Review of Powhatan Salt Company  
Solution Mining Well Permits for Storage of Natural Gas  
Liquids at the Mountaineer NGL Storage Facility near  
Clarington, Ohio

March 24, 2021

The ODNR opened a 30-day comment period on these permits on January 7th. PSE Healthy Energy (PSE) was tasked by the Environmental Integrity Project and Earthjustice with reviewing these permit applications. PSE developed a report dated February 4, 2021 outlining technical concerns with permit applications. After obligatory consideration of public comments, including comments submitted by PSE, the ODNR then issued revised well permits on March 8, 2021 and opened another 30-day public comment period. PSE was tasked by the Environmental Integrity Project and Earthjustice with reviewing these revised permit applications.

**Figure 5.** Modified screen shot from the ODNR Oil and Gas Well Viewer illustrating the locations of salt solution mining wells (Salt 1, Salt 2, Salt 3), location of Core Hole 1, horizontal extensions of hydraulically fractured oil and gas wells, and 100-year floodplain (shaded blue)

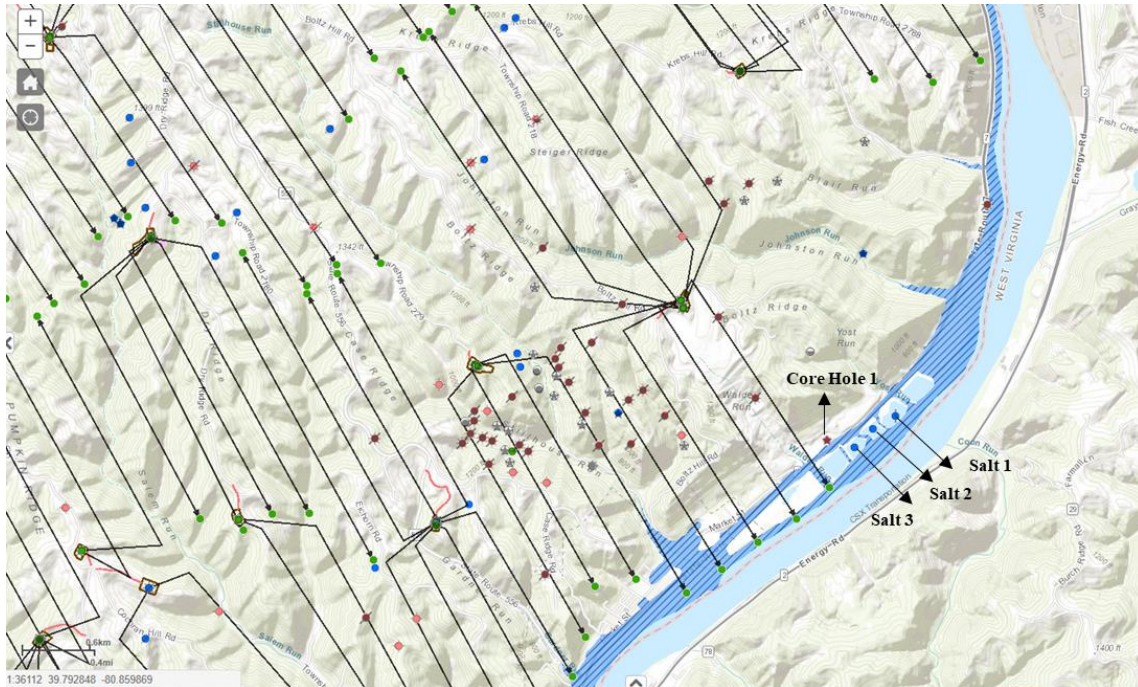
Contingency for Flooding					As illustrated in Figure 5, all 3 salt solution mining wells are within a 100-year floodplain. The operator needs to specify what contingencies are necessary in the event of flooding.	No response
<b>Cavern Integrity Monitoring</b>						
Cavern Integrity Monitoring Program		X		X	API 1170, 1171, and 1115 require that the integrity of the well and salt cavern system must be maintained and monitored. Once in operation and throughout its life, a cavern system must be monitored to ensure functional integrity. There must be a formal written integrity monitoring program that must contain, at a minimum, the following components: (1) identification of cavern system components to be monitored; (2) monitoring methods specifying the type of method and frequency of application; (3) cavern volume and growth monitoring; (4) analysis of data from inspections, reporting, and archiving of results; (5) periodic reviews of the monitoring program for effectiveness; and (6) subsidence monitoring. The permit application does not contain a formal written integrity monitoring program. This is absolutely critical for safe operation of NGL storage. PSC must include a cavern integrity monitoring program in permit applications or describe when a cavern integrity monitoring program will be provided to the ODNR.	No Response

**Figure 9.** Approximate spacing of the proposed salt well caverns as determined in ArcGIS 10.8. Salt well locations were taken from the permit materials, and cavern edges were estimated by extending a 300 ft (the proposed cavern diameter) buffer from each well location.

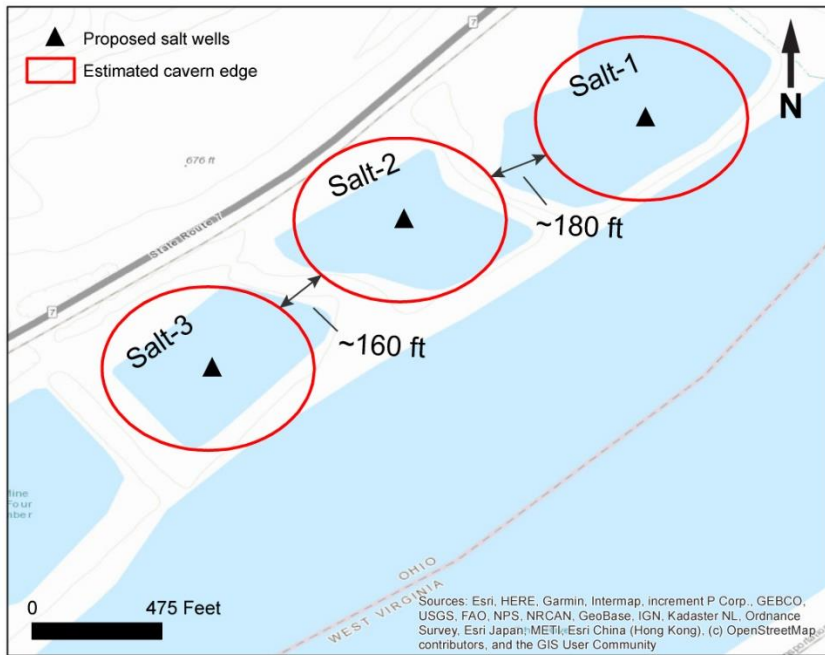
concern is pillar spacing between caverns at the PSC facility itself. The permit applications do not include a discussion of planned P:D ratios or pillar space at all. Eyermann (2017) states that the average diameter of caverns at the PSC facility will be 300 feet. Hence, there must be a least 300 feet but preferably 600 to 900 feet of spacing between caverns. Using an approximate (mapping in ArcGIS) cavern diameter of 300 feet, it appears that spacing between neighboring caverns will be approximately 160 to 180 feet (P:D ratios of 0.53 and 0.60, respectively) (Figure 9). Thus, from this estimation, pillar distances between salt cavern 1 and salt cavern 2 and salt cavern 2 and salt cavern 3 do not appear to be sufficient. As such, information on anticipated pillar distances should be provided to the ODNR. If possible, geomechanical modeling should be used to determine adequate salt thickness between caverns.

Separation Distance	X		X		API RP 1170 and 1115 recommend a S:D ratio greater than 2:1 where S equals the separation distance between the centers of two adjacent caverns and D equals the average of the maximum diameter of the two caverns. According to the permit materials, the distance between the centers of salt cavern 1 and salt cavern 2 and salt cavern 2 and salt cavern 3 appear to be 778 and 769 feet, respectively using ArcGIS. Thus, the S:D ratios for these caverns (~2.6) appear to satisfy the recommendations of API RP 1170 and 1115. However, permit applications do not include a discussion of S:D ratios.	No response
Source Water and Brine Monitoring		X		X	API RP 1170 and 1115 stipulate that the operator to measure the rate and salinity of water entering and brine leaving the cavern. This facilitates calculation of the volume and efficiency of the solution-mining process source water and resultant brine enables estimation of cavern growth. The brine should be checked for minerals, including the percentage of NaCl, KCL, and MgCl <sub>2</sub> . Higher solubility salts KCl and MgCl <sub>2</sub> can undercut upper strata and cause strain or collapse. Permit applications indicate the water used for debrining will be sampled and analyzed quarterly. Brine will be sampled twice per day for specific gravity. The daily brine samples will be consolidated for more detailed chemical analysis on a monthly basis. In the permit applications, chemical analysis is presented for the source water which is the Ohio River, however the data presented generates both concerns and questions. Specifically, the concentration of arsenic is provided as 100 ppm (mg/L). This arsenic concentration is several orders of magnitude higher than nearby water quality measurements made by the U.S. Geological Survey. Measurements made at a station on the Ohio River (site number 395516080451501) on November 7, 2019 indicate an arsenic concentration of 0.46 ppb (µg/L). Hence, it is highly unlikely that the Ohio River has arsenic concentrations at 100 mg/L. If the units of this concentration were misreported as ppm, with the measured concentration being 100 ppb (µg/L) instead of 100 ppm, this concentration would still be exceeding high. This appears to be an example of sloppy reporting. Other elements are given in concentrations of GPL (grams per liter, grains per liter?). Grains per liter is a	No response
